North Anna SLRA

RAI B2.1.35-1:

RAI B2.1.7-1: Pitting and Crevice Corrosion in Reactor Vessel Internals

RAI B2.1.15-1:

Fire Pump Engine Photos

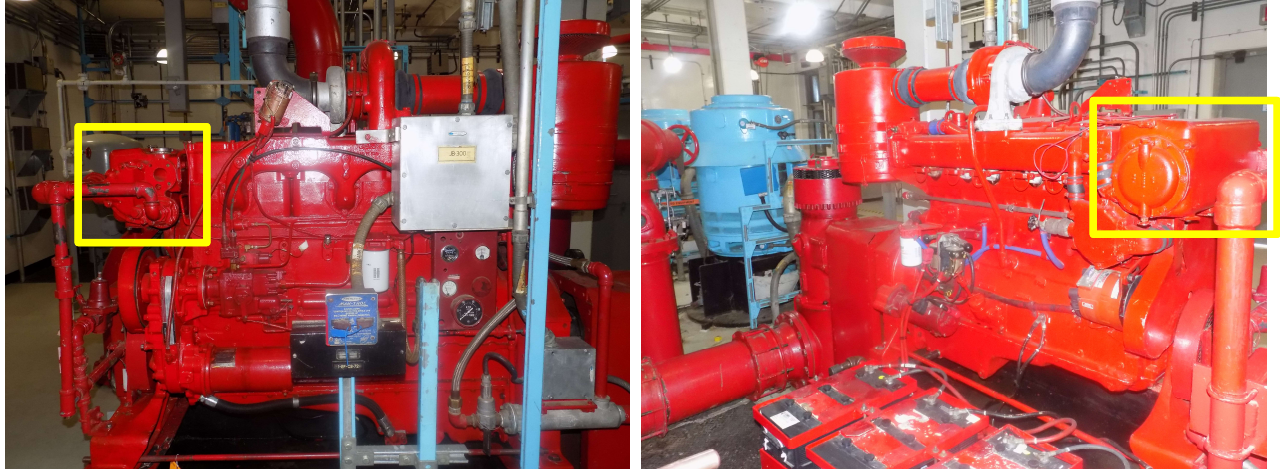
- Diesel-driven fire pump engine and skid-mounted subcomponents were originally addressed in SLRA as an active assembly, not subject to AMR per 10 CFR 54.21(a)(1)(i)
 - Active status is consistent with NUREG-2192, Table 2.1-6 item 55. Equipment performance is managed via Maintenance Rule
 - Similar component was recently questioned at Peach Bottom and active status was accepted in RAI response, documented in SER 2.3.3.14.2
 - Dominion believes Table 2.3-2 excerpt is applicable to diesel generators, not fire pump diesel engines, which typically have integral subcomponents
- Staff noted that the engine coolant HX had experienced a tube failure in 2017; RAI questioned ability of active component testing to identify degradation prior to failure
- Dominion proposed new commitment #49 for periodic replacement in RAI response. Therefore, the HX is not subject to AMR per 10 CFR 54.21(a)(1)(ii).

#	Program	Commitment	AMP	Implementation
49	N/A	Procedures will be developed to replace the diesel-driven fire pump engine heat exchanger tube bundle on a 20-year frequency and require the heat exchanger tube bundle for the spare engine to be replaced prior to being placed in-service with the diesel-driven fire pump. (Added – RAI Set 1)	N/A	Procedures to replace the diesel-driven fire pump heat exchanger tube bundle will be in place 5 years prior to the heat exchanger tube bundle achieving 20 years of active service.
